Product Change Notification

Product Group: Diodes / June 03rd, 2013 / PCN-DD-005-2013 Rev 0

Bare copper lead frame and plating line

TO-247 AC

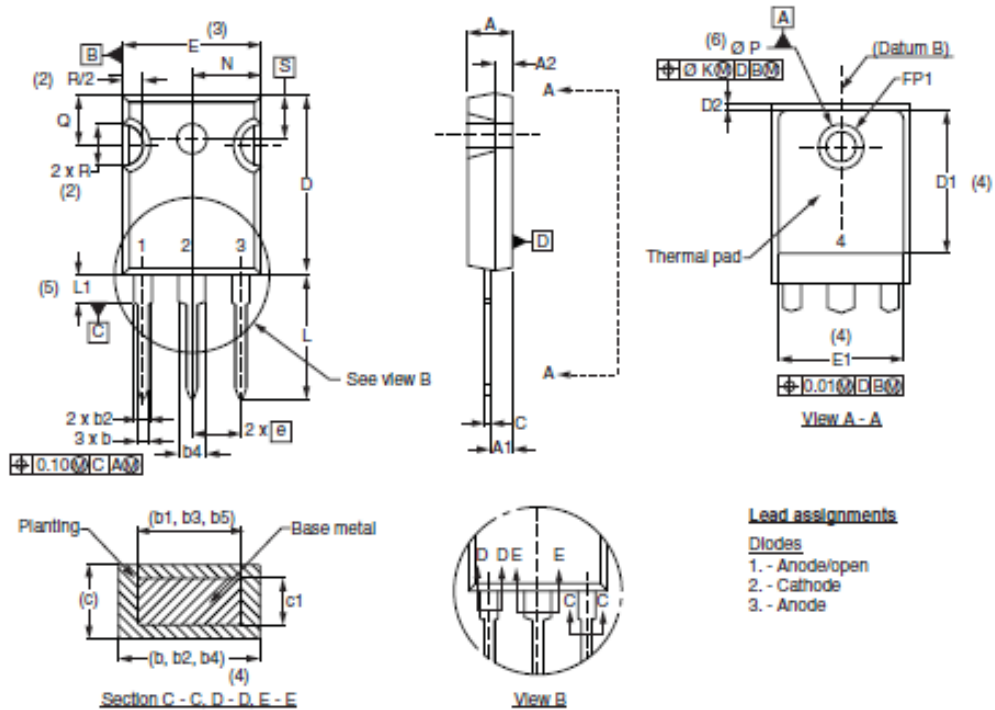
Termination finish (process/material) for TO-220 Full Pak and TO-247 will change from hot solder dip (Sn 99.3%, Cu 0.7%) to matte tin plating (Sn 100%). TO-247's heatsink and leads thickness lead frame will change from 79 mils to 50 mils and from 24 mils to 20 mils respectively: package outline dimension will be reviewed accordingly. See annex.

TO-247 Package Outline Dimension

From [mm (inches)]		To [mm(inches)]	
	min	Max	min	Max
A2	1.50 (0.059)	2.49 (0.098)	1.17 (0.046)	1.37 (0.054)
b3	1.65 (0.065)	2.37 (0.094)	1.65 (0.065)	2.34 (0.092)
c	0.38 (0.015)	0.86 (0.034)	0.38 (0.015)	0.89 (0.035)
c1	0.38 (0.015)	0.76 (0.030)	0.38 (0.015)	0.84 (0.033)
D2	0.51 (0.020)	1.3 (0.051)	0.51 (0.020)	1.35 (0.053)
E1	13.72 (0.540)	-	13.46 (0.53)	
ΦK	2.54 (0.010)		0.254 (0.010)	
ΦP1	-	6.98 (0.275)	-	7.39 (0.291)
